# **NATIONAL DIOXIN STUDY TIER 4— COMBUSTION SOURCES**

## **Quality Assurance Evaluation**

EPA-450/4-84-014f

Figure 1. Configuration of primary and back-up sorbent modules in Modified Method 5 sampling train.

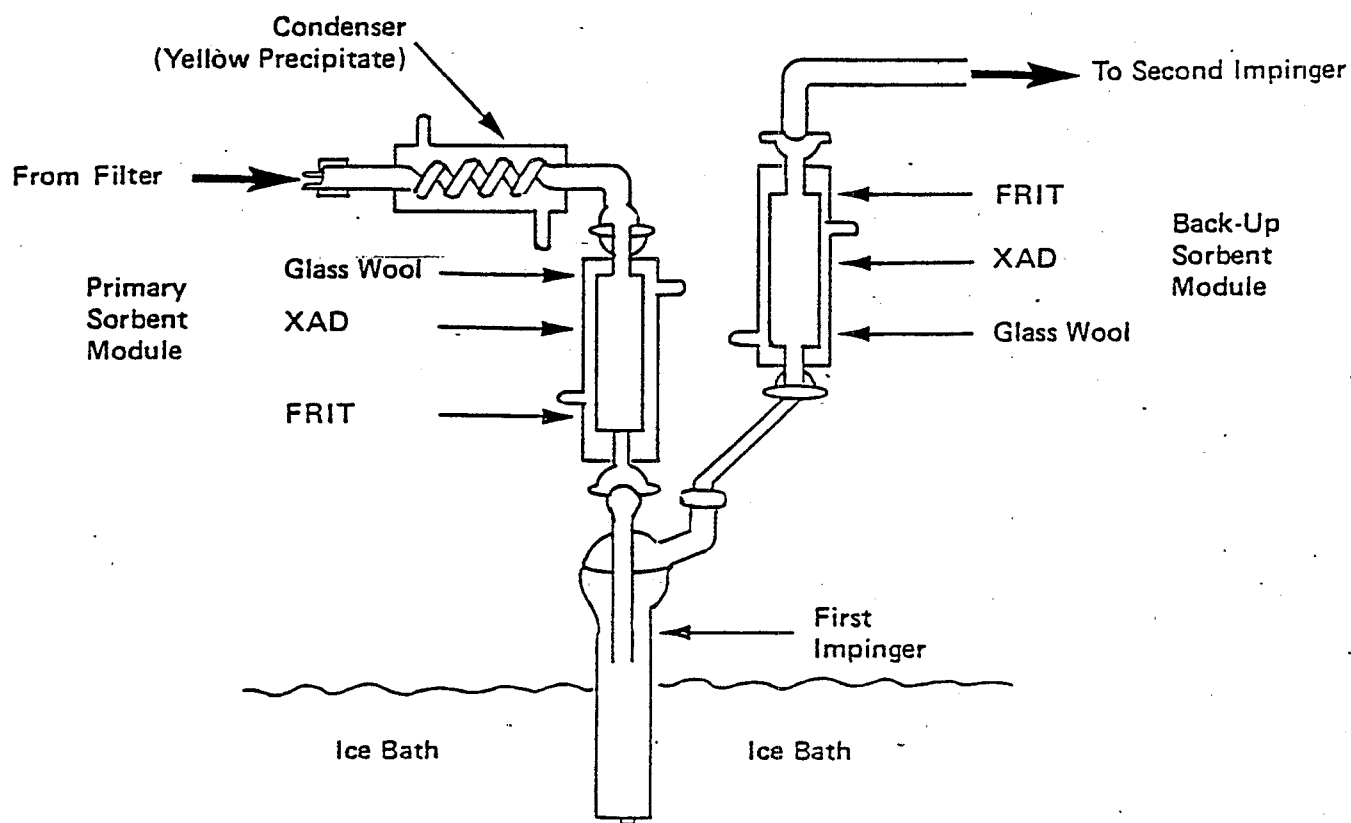
The Modified Method 5 sampling train in use at the Site MET-A tests was unique in that a second XAD resin cartridge was added to the system just after the first impinger, as illustrated in Figure 1. This configuration, which was requested by EPA, was designed to mitigate concerns regarding the horizontal position of the XAD condenser. (Although the horizontal mounting of the condenser had been approved by EPA during previous Tier 4 tests, officials from a State Agency remained concerned about an increased potential for organic compounds breaking through the resin.) The set-up and operation of the second XAD resin cartridge appeared to be acceptable. Furthermore, with one exception, operation of the entire train appeared normal. The one exception involved the formation of a yellow precipitate in

the condenser, between the filter and the first XAD resin cartridge. The nature of this precipitate is unknown, although its color suggests it may be chloride. Radian reported that the precipitate was easily removed with acetone.
